## **REMARKS**

Inventor: Schmiel et al.  
Docket No.: 6683.47US11  
Title: Reply to Office Action of December 9, 2003  
Serial No.: 09/921,008  
ANNOTATED SHEET

FIG. 13

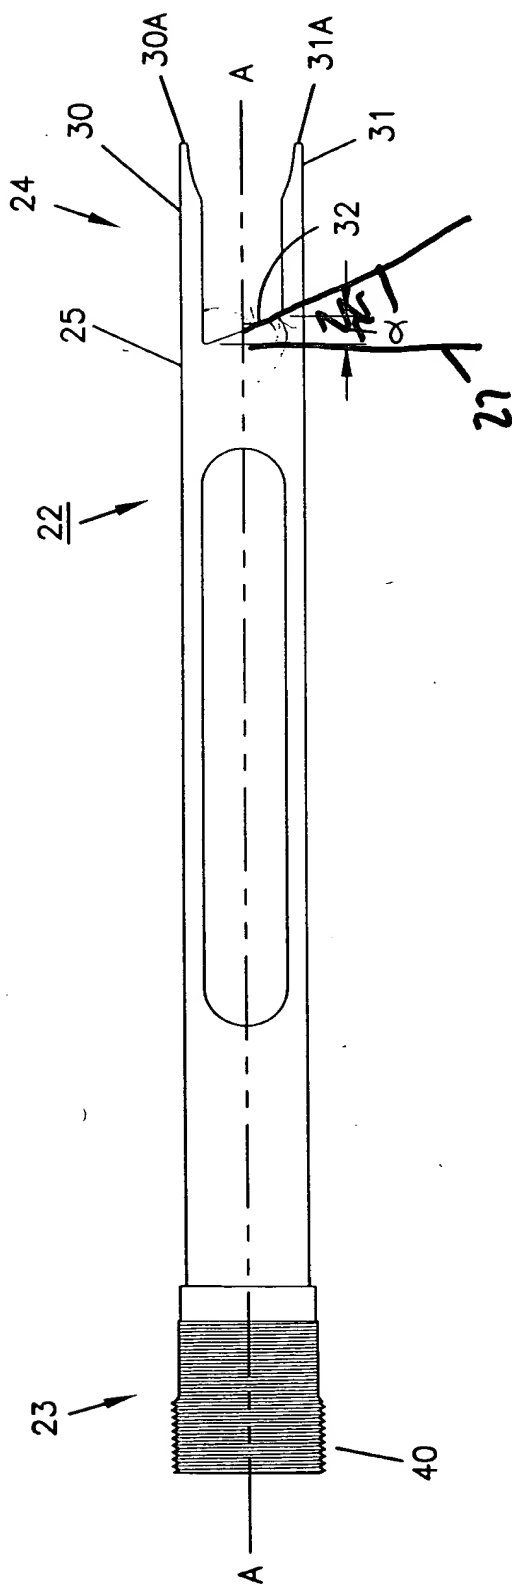
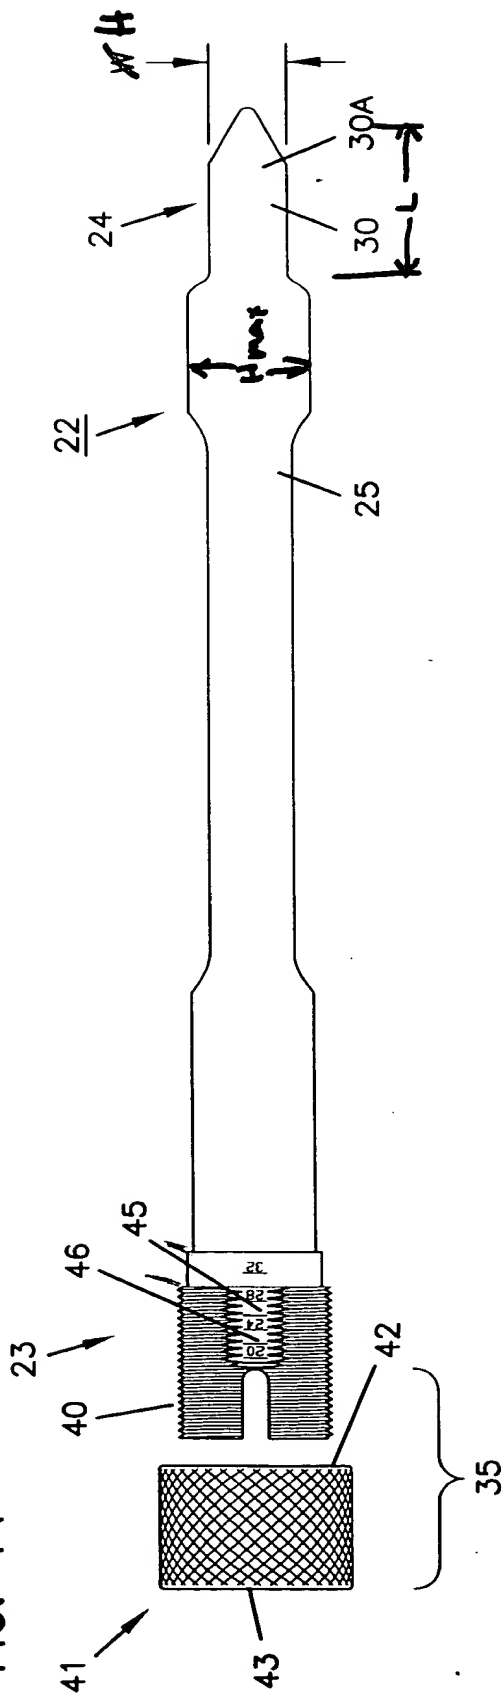
Applicants propose to amend Figures 13, 14, 15 and 18. The particular amendments are described in the Proposed Amendment to the Drawing section. In addition, attached hereto are clean and red-line copies of the above identified amend figures. As discussed in the Proposed Amendment to the Drawing section, the proposed amendments add no new subject matter.
